17172-18-01

Date: August 30, 2019

**VOLCANO SCHOOL OF ARTS AND SCIENCE
PHASE – 1 SITE IMPROVEMENTS****Addendum #1****RFI #1 and Responses:**

PHASE 1 SITE IMPROVEMENTS FOR:
VOLCANO SCHOOL OF ARTS & SCIENCES:
KEAKEALANI CAMPUS DEVELOPMENT
VOLCANO VILLAGE, ISLAND OF HAWAII

C-003

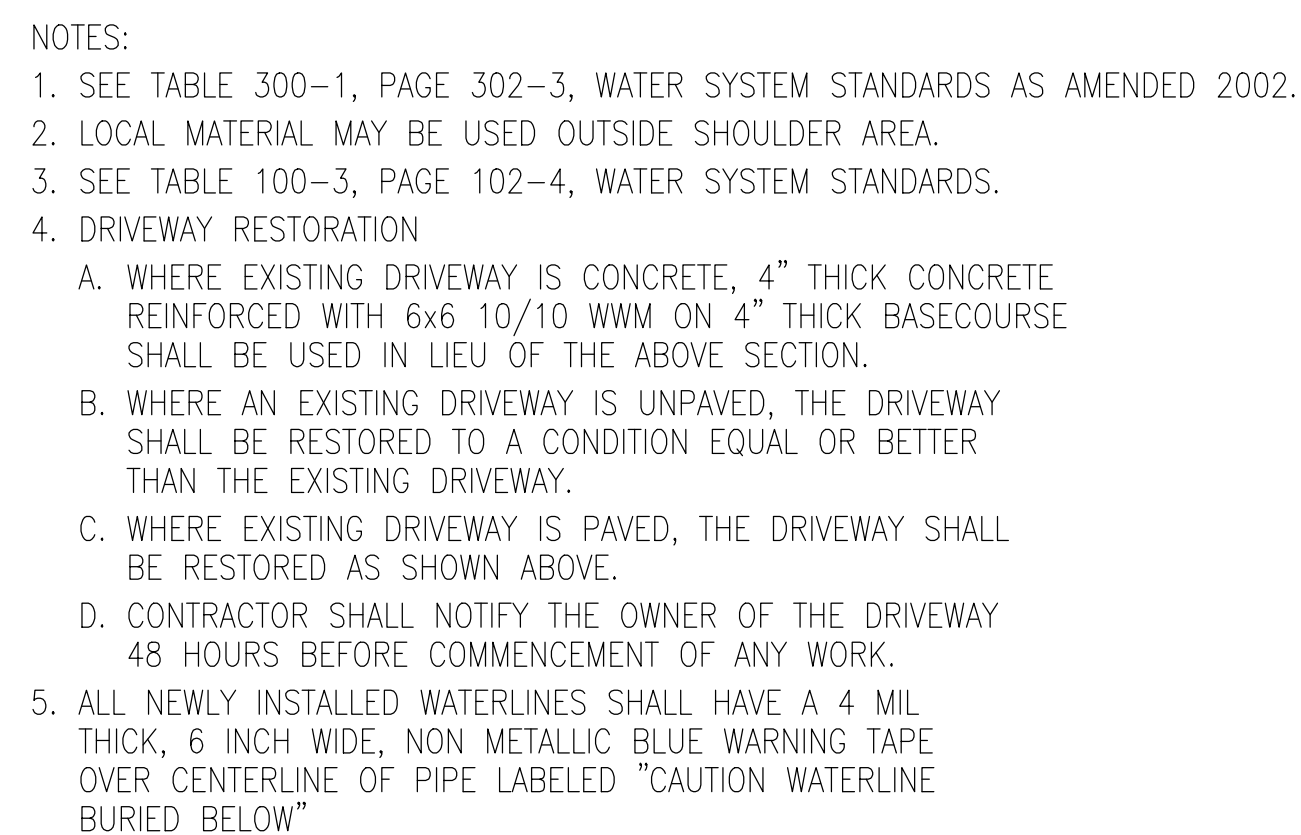
Sheet C-003: Detail 5/C-003 removed from project. Fire hydrant standpipe detail revised
